Improving the CR loss budget

Piers Dawe, Nvidia

Revised 10 Aug 2021

Example of switch PCB losses

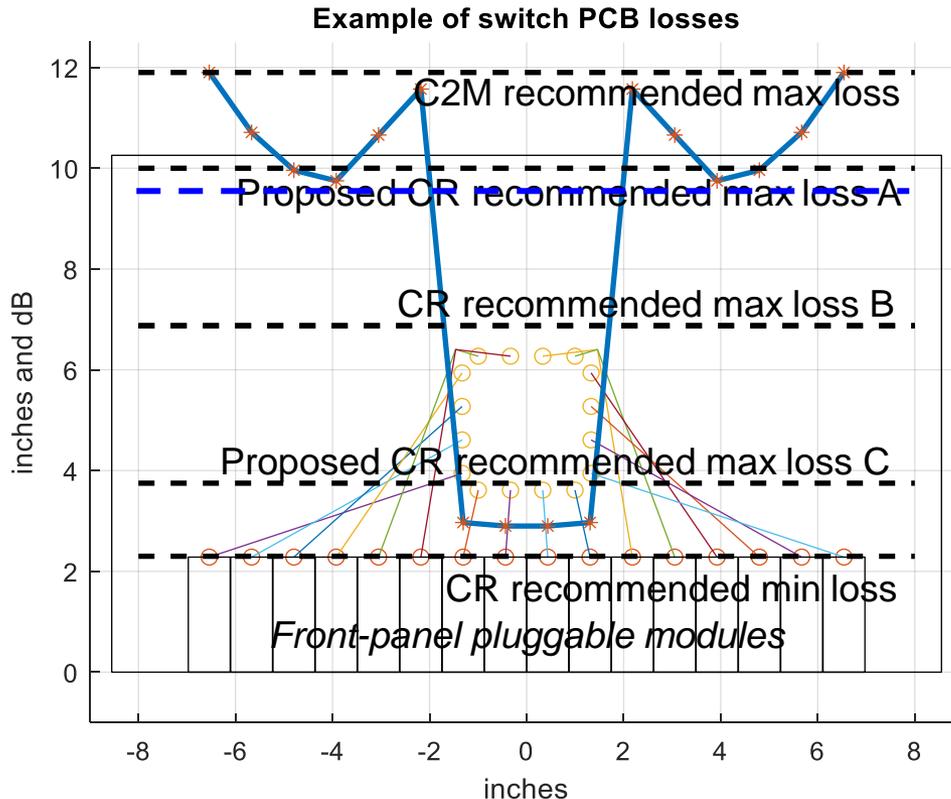
- In this example, all paths are below the C2M recommended max loss (good)
- But only 8 out of 32 are within the CR recommended max loss (bad)
- Other distributions are possible (see next slide) but the issue remains
- There are fixes (see e.g. [2]) but with costs

6.875/2.3 = 3:1 is too small a max/min loss ratio anyway

At 25G/lane and 50 G/lane we had 5.8:1

Want at least about 4:1. This example 4.1:1

Another example of switch PCB losses

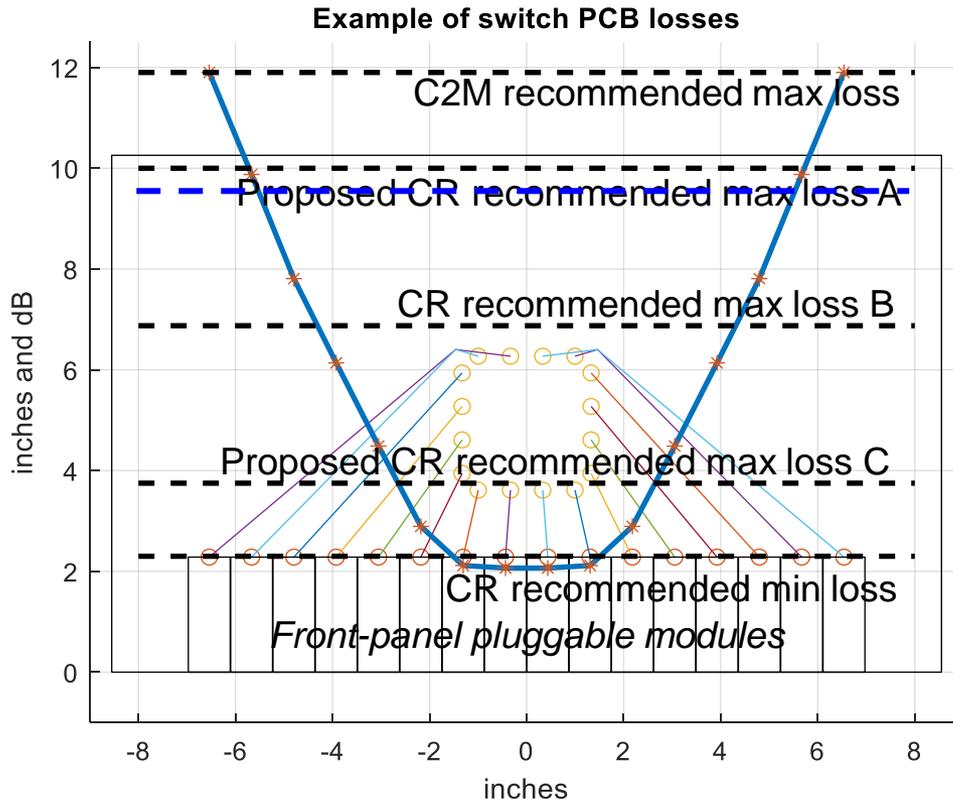
6.875/2.3 = 3:1 is too small a max/min loss ratio anyway

At 25G/lane and 50 G/lane we had 5.8:1

Want at least about 4:1. This example 5.8:1

- In this example, all paths are below the C2M recommended max loss but it needs lower loss/in than previous example
- But only 10 out of 32 are within the CR recommended max loss (bad)
- 4 paths are below the C2M recommended minimum
- There are fixes (see e.g. [2]) but with costs

Figure 162A-3—Cable assembly, host, and test fixture insertion loss at 26.56 GHz

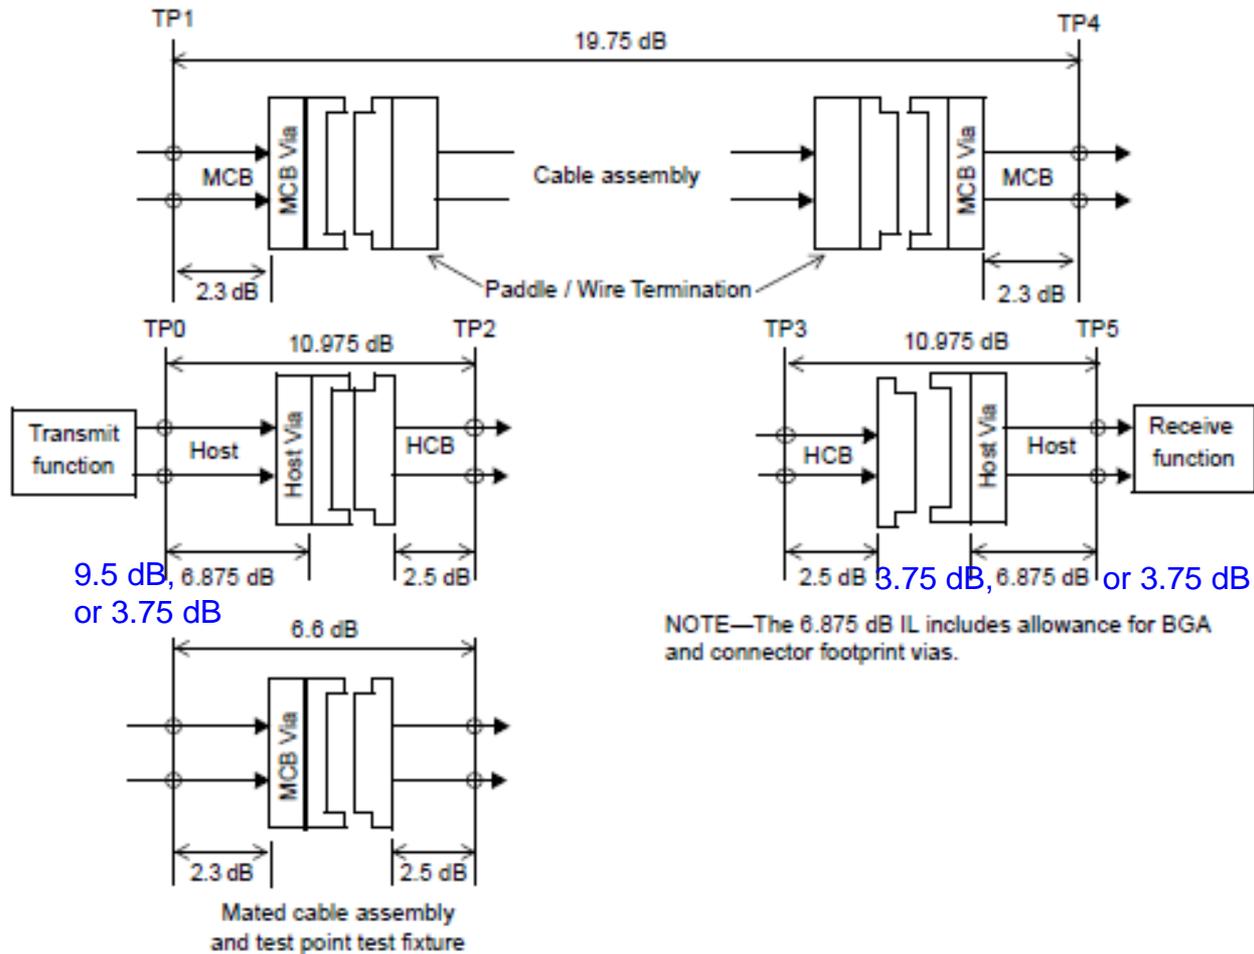
- Adjust figures 162A-3 and 4

Figure 162A-4—Channel insertion loss at 26.56 GHz

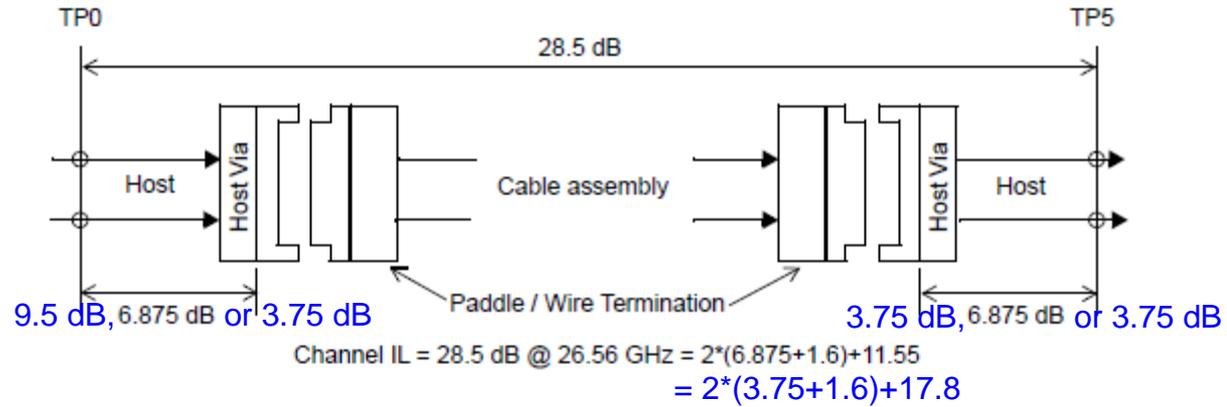
- 2 classes of cable, "short" or regular (19.75 dB, as today) and "long", $19.75 + 2 * (6.875 - 3.75) - 0.5 = 19.75 + 5.75 = 25.5$ dB max
 - Achievable cable length 3 m
- Long cables connect port types C at both ends, short cables connect a valid (see earlier) combination of A, B, C
 - Each host knows its loss ability, learns remote loss ability from training frame, learns cable loss class from its memory map
- In 162.11.2, cable assembly insertion loss, change text to refer to Table 162-17
- In 162.11.7.1.1 and 162.11.7.1.2 use $z_p = 30.7$ mm for the "long" cable
- In Table 162A-1, add a column for the A-short-A scenario (ILCamax differs) as on next slide
- Figure 162A-3 stays as slide 19, Figure 162A-4 as on slide 24
